Pig Iron Plant Project - Saguenay

Environmental Impact Study submitted to the Ministry of Sustainable Development,
Environment and the Fight against Climate Change (MDDELCC)

Addenda A

Questions and comments on the construction of a pig iron plant on the territory of the Municipality of Saguenay by the North Atlantic Iron Corporation

Figure 3.2 Rev01 Pig Iron Production Facility Simplified Process Flow Diagram

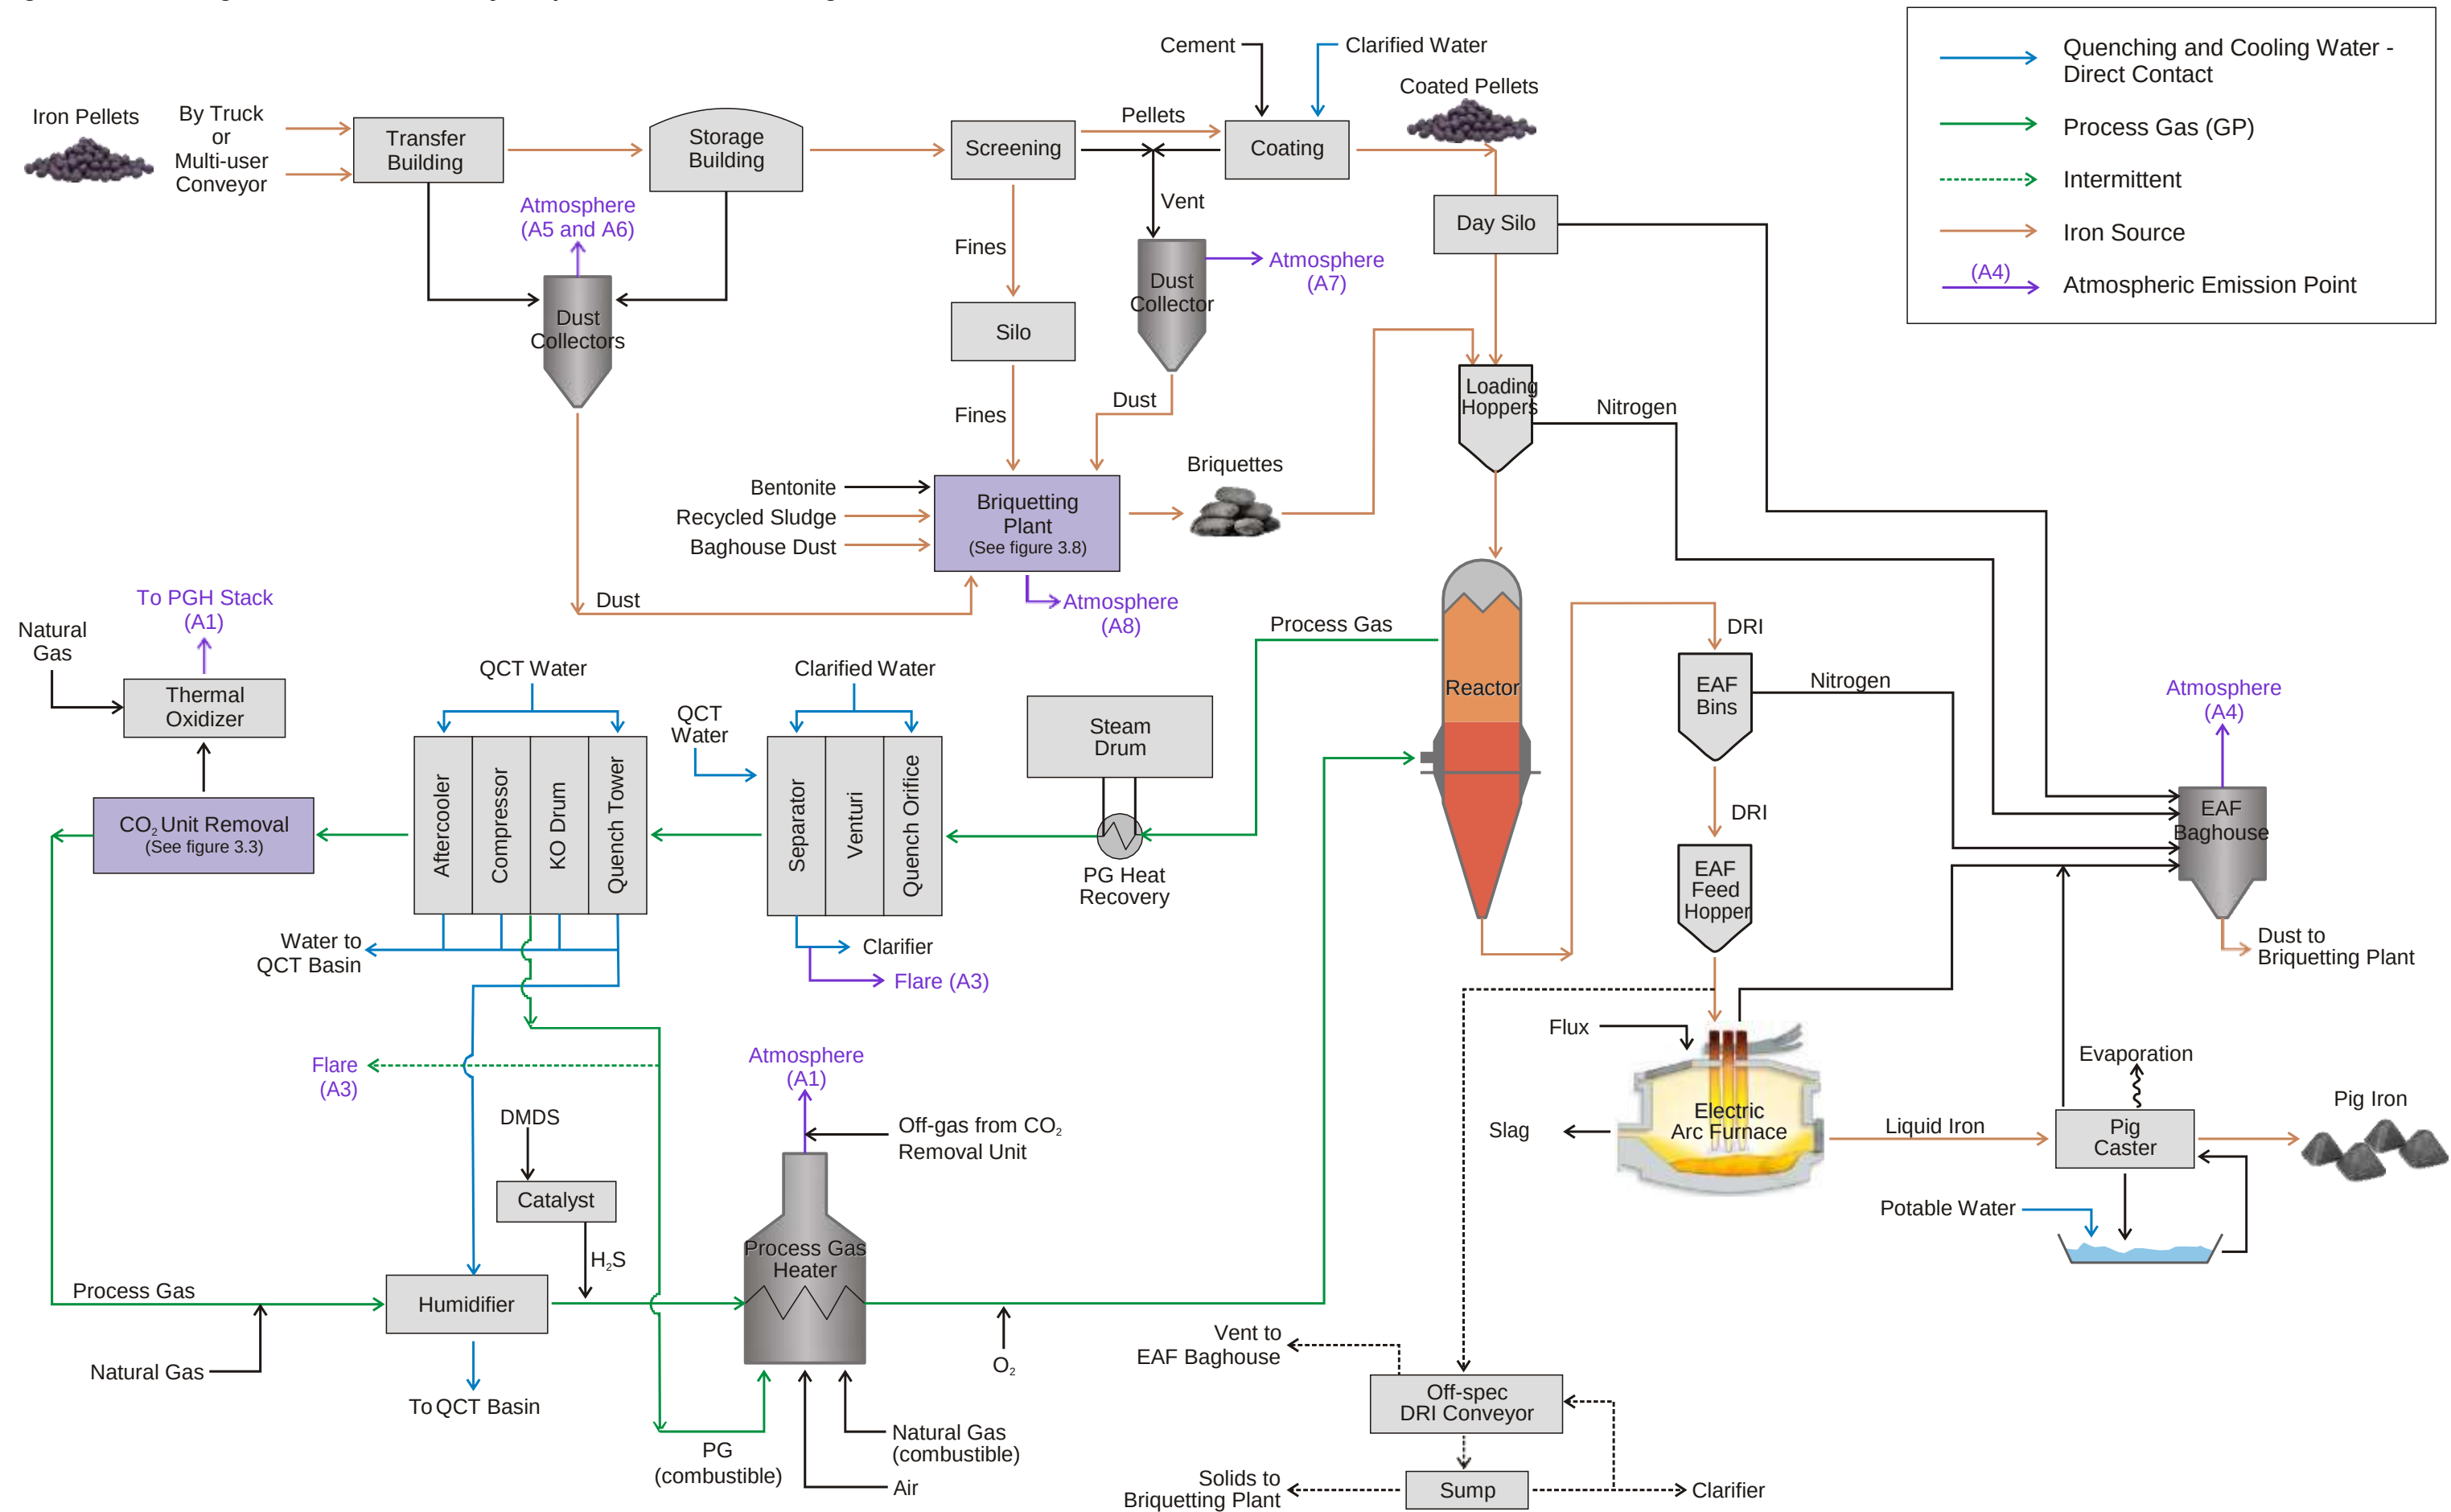
Figure 3.2 shows the simplified pig iron process flow diagram (section 3 of the main report). The Proponent needs to provide a more detailed description of the gas treatment process in order to facilitate understanding. In addition, for each stage of the process gas treatment process, the Proponent needs to indicate the chemical reactions used to monitor the progress of the treatment.

Figure 3.2 (Simplified process diagram of the pig iron plant) identifies that atmospheric emissions of agglomeration unit could be directed to the dust collector of the electric arc furnace (EAF).

It is found in Figure 3.2 that nitrogen from the buffer silos of direct reduced iron (DRI) is directed to the EAF dust collector. The Proponent needs to explain where this nitrogen comes from. Since a dust collector does not purify such substances (for example, NOX), they should be considered for the assessment of project impacts on the quality of the atmosphere.

In Figure 3.2, the MDEA should be identified as an input to the CO₂ removal unit and natural gas as fuel for the thermal oxidation unit.

Figure 3.2 shows that emissions from buffer silos are sent to the dust collector of the melting and casting building (EAF dust collector). The Proponent needs to explain why these emissions

In addition, Figure 3.2 has been modified (Figure 3.2 Rev01) and is presented at the end of this section.

Figure 3.2 has been corrected (Figure 3.2 Rev01), it is presented at the end of this section. Treated emissions from the agglomeration unit will be emitted into the atmosphere through a single chimney and will not be directed to the dust collector of the electric arc furnace (A4 emission point), all as described in Section D1.6 of Annex D1. This is the A8 emission point.

Figure 3.2 was reviewed (Figure 3.2 Rev01) to identify natural gas as fuel in thermal oxidation unit. A reference has been added to Figure 3.3 in the “CO₂ removal unit” box.

Figure 3.5 Rev01 Simplified Diagram : Industrial Wastewater Treatment

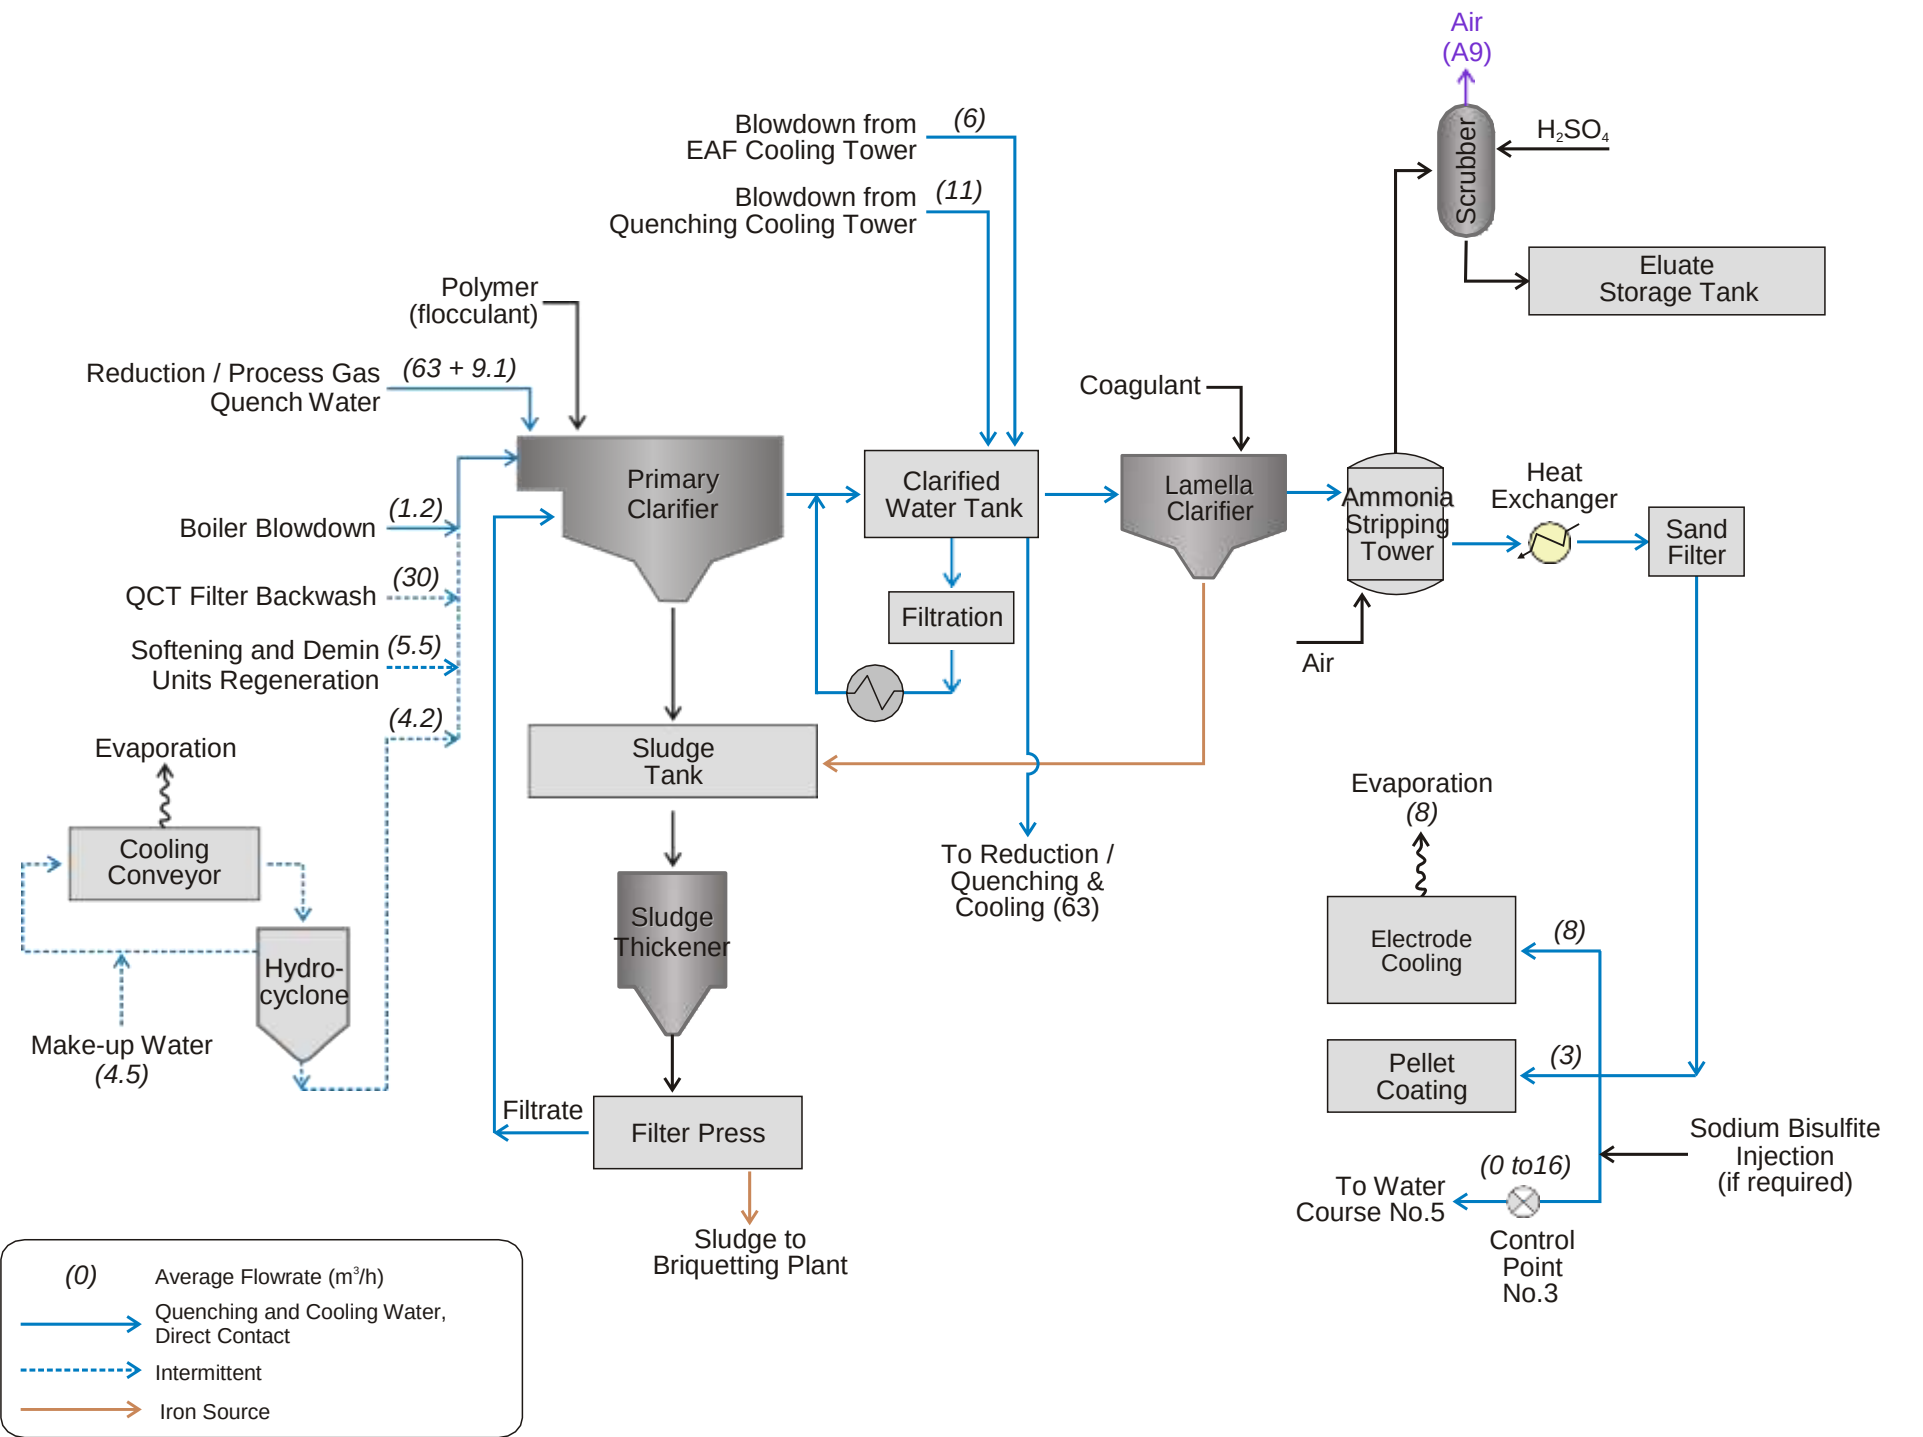
In Figure 3.5 showing the process water treatment diagram, it appears found sodium bisulphite is injected late in the process, i.e. immediately before discharge into Watercourse # 5. The Proponent should explain why chlorine is not destroyed further upstream in the treatment process, i.e. at the exit of the clarified water basin.

It is important to note that the cooling of the effluent is already planned in the design of the project. Figure 3.5 was reviewed (Figure 3.5 Rev01) to indicate the presence of a heat exchanger. We should also mention that another correction was made to the figure; the precipitation of solids and metals in the lamella clarifier occurs before ammonia stripping and not after. Therefore, significant efforts have already been made to reduce the temperature of the final effluent by 50%. The waters coming out of the clarified water basin are at a temperature of about 80°C. The passage in the ammonia extraction tower will lower this temperature by about fifteen degrees. A heat exchanger placed before the sand filter can reduce the temperature of the final effluent by 25° C, leading to a discharge temperature of 40°C.
